Date: 22 December 2017

Report No: DPE/2017-1

RE: Review of the Mine Plan and the Subsidence Risks Associated with the Proposed Mine Plan – Hume Coal

Figure 1. Illustration of the proposed layout showing the different coal pillar types (after Mine Advice, 2017)

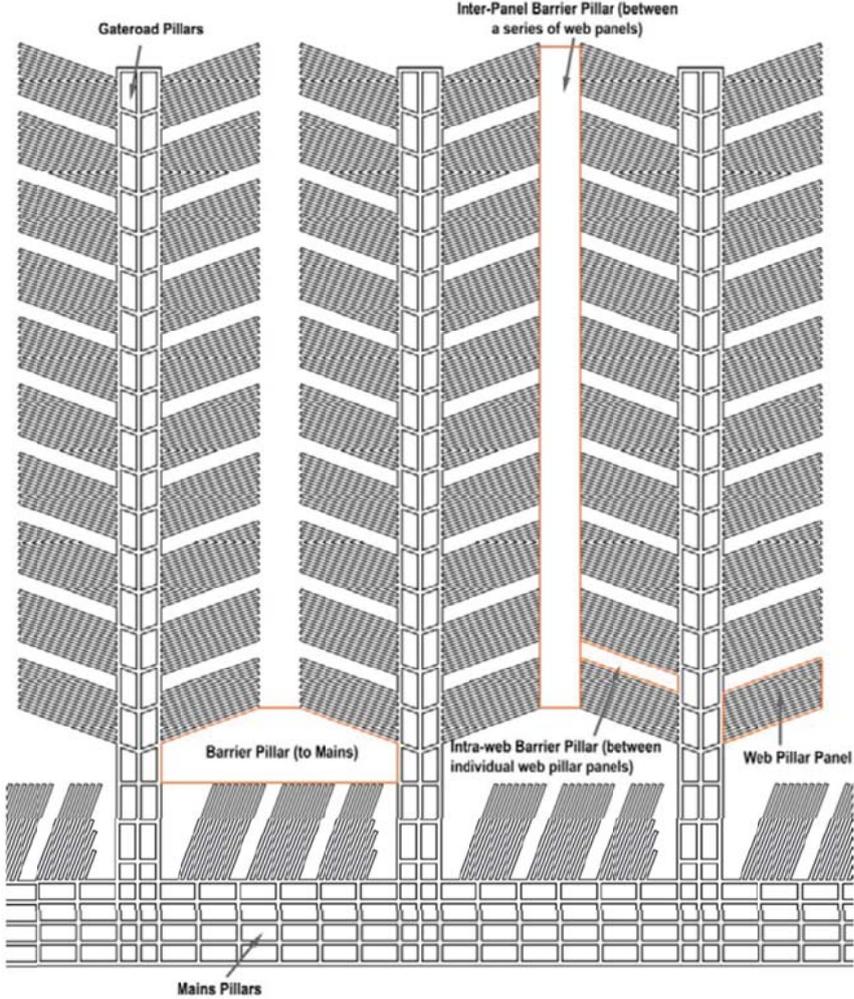
The proposed web pillar sizes are also unique as the reviewer is unaware of any recent pillar design study that systematically utilised such narrow web pillars for long-term stability.

An important requirement of this project is that the coal pillar system left behind will be stable over the long-term (using a suitably high Factor of Safety (FoS) against pillar failure and ensuring that the low pillar width to mining

height ratio pillars are protected by suitably large pillars). Figure 1 shows the proposed layout and the different coal pillar types. Table 1 presents the proposed pillar dimensions for the shallowest to deepest sections of the mine.

In the proposed layout, the web-panel widths are kept relatively narrow (i.e., 54m to 58.6m) in order to ensure that the panels are in a sub-critical state and that the overburden bridges between the intra-web pillars. This concept has been applied in many mining projects to limit the pillar loading and to minimise the surface subsidence, including in highwall mining.

The proposed backfilling allows the mine to store tailings underground and to provide some form of confinement to the proposed web pillars. The Mine Advice reports make no specific reference to the timing of backfilling. In addition, no information regarding the properties of the backfilling is provided in the report.
